Subject Implications of gypsum addition

**Environment Protection Licence 1548
CWS Waste Management Option 4 Remediation Design and Proposed Validation of Treatment
EPA comment on Ramboll response dated 08 June 2018**

**HYDRO ALUMINIUM KURRI KURRI CAPPED WASTE STOCKPILE
TREATMENT: RESPONSE TO EPA FEEDBACK**

Attachment A – Response to EPA comments issued on 27 April 2018

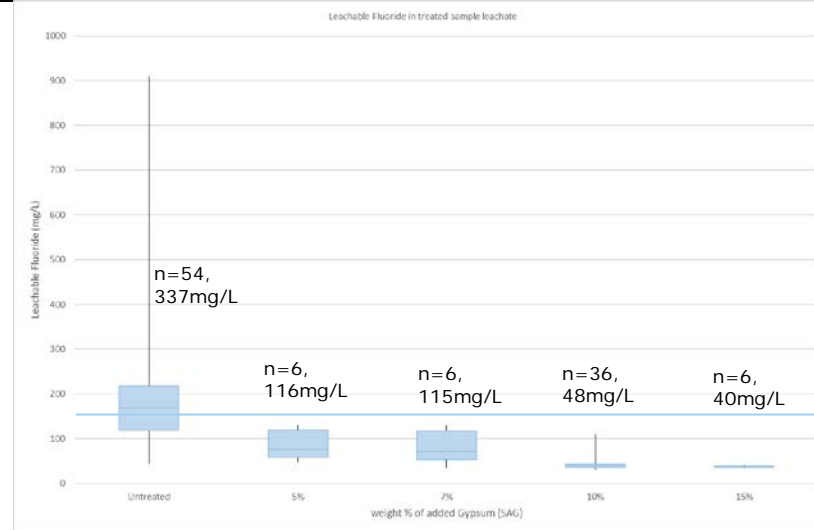
<p>ACTION (1f): Hydro be requested to provide the following information.</p> <p>1. An analysis and discussion of the chemistry explaining SAG reaction with fluoride. The analysis should demonstrate the mechanism/s involved are well understood and that the chosen gypsum application rate is appropriate for use.</p>	<p>Refer to Question 1(b). The chosen gypsum application rate was adopted based on a series of testing using a range of application rates. Whilst all application rates trialled passed the CCO requirements, an application of an added 10% by weight was adopted as this gave a factor of safety of around three. That is, the leachable concentration of F when tested in accordance with the EPA prescribed method was 48mg/L⁵, or less than one third of the target concentration of 150mg/L.</p> <p>As a further check on validity of the application rate, a stoichiometric calculation of the moles of soluble F in the mass compared to the moles of Ca added in gypsum was undertaken. The calculation was completed two ways based on the estimated mass of F in the waste. The mass can be estimated a number of ways as follows:</p> <ol style="list-style-type: none"> As before, the mass of spent pot lining is estimated as 35000T of the total mass. The MSDS reports that 7 to 22% of first cut spent pot lining can comprise total F. On this basis there is 7700T of F in the waste. It is further estimated that only 17% of this total F mass comprises soluble F as approximately 80% is cryolite (Na₃AlF₆) and 3% is Calcium Fluoride, both of which are insoluble in water. Therefore, there is an approximate 1330T of soluble F presented in the waste, when adopting the 22% upper limit of total F.

2. An alternate method to calculate the total mass of F, is to adopt the 95% UCL mean of the untreated waste data set (Table 2-1 of the report). Using the 95% UCL and applying this to the full 240000T of waste, and assuming the same proportion (17%) of this mass is soluble, equates to 1260 T of soluble F.
3. Using the 95% UCL average of soluble F of 337 mg/L determined by TCLP testing, and calculating the total mass of soluble F within the waste. This method uses the leachable value to calculate a total soluble F concentration in the mass. Interestingly the soluble concentration calculated by this method was 22% of the 95%UCL total concentration determined for the waste. This is reasonably consistent with the estimated 17% of total F that is soluble. This calculation resulted in an estimate 1620 T of soluble F and was used in the following calculation.

The mass of gypsum proposed to be added to the waste is 24000T⁶, of which 22800T is actual gypsum assuming 10% of impurities as per the SDS. This equates to 5018T (or 1.25e8 mol) of Ca available for reaction with 1620T of soluble F (or 8.51e7 mol). As the formation of CaF₂ consumes two molecules of F to one molecule of Ca, there is an excess of Ca remaining (8.99e7 mol) or 3600T of calcium, which equates to 16280T of gypsum. This calculation demonstrates that there is sufficient calcium available in the addition of gypsum to stabilise the soluble F ions present in the waste.

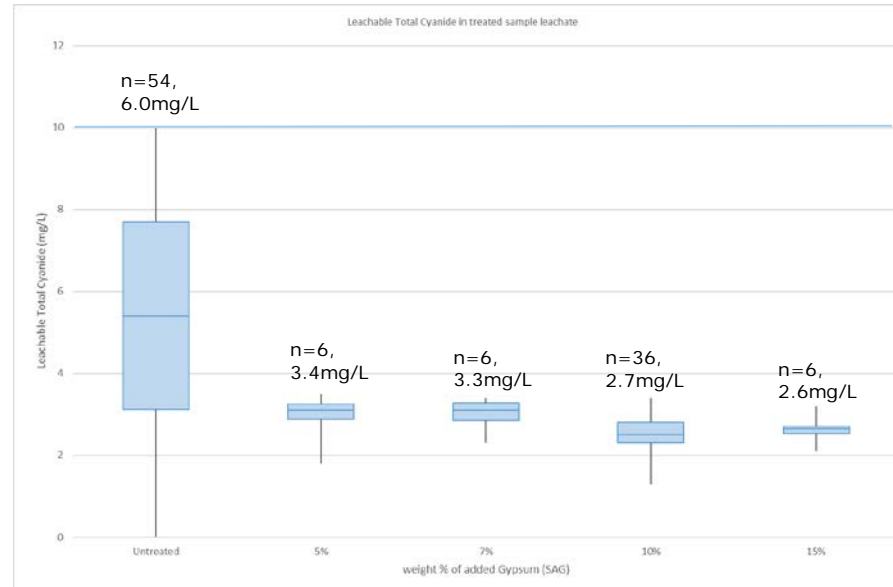
2. Test results for non-treated samples, and a discussion and analysis of these results. The analysis may assist to explain observed variability in the results and to demonstrate the effectiveness of the use of gypsum.

The figure above shows the trial results (Figure 8-4 of the report) with untreated data from previous samples (data presented in Table 2-1 of the report) included. Table 2-1 of the report shows untreated samples subject to a TCLP leachate test reporting a 95% UCL average of 337 mg/L. The figure above shows the box and whisker representation of this data set and indicates that three quartiles of the untreated data are below 217mg/L, however a whisker extending to 909 mg/L is observed. The distribution observed in the data is not unexpected as the waste includes fragments of spent pot lining which are expected to produce high leachable fluoride levels when subject to the analysis. As presented the estimated mass of spent pot lining within the overall waste mass is 35000T of first cut spent pot lining in approximately 240000T of waste, less than 15% of the overall waste mass.

The method of testing untreated samples was to select the sample for analysis and then crush and test. As the sample size was variable, this method sometimes results in a cobble sized 'piece' being selected and crushed for analysis. Where this was spent pot lining, a high leachable F⁻ concentration resulted. Whereas, for the treatability trials the whole sample was crushed, mixed and then sampled for TCLP analysis. Therefore increased homogeneity is expected from the treatability trials, and this is also expected to best replicate any leachate derived from the waste following mixing with gypsum and relocation to the new cell.

The same effect is observed to Total Cyanide, noting the data presented is for Total Cyanide as required under the CCO, not WAD or Free Cyanide.
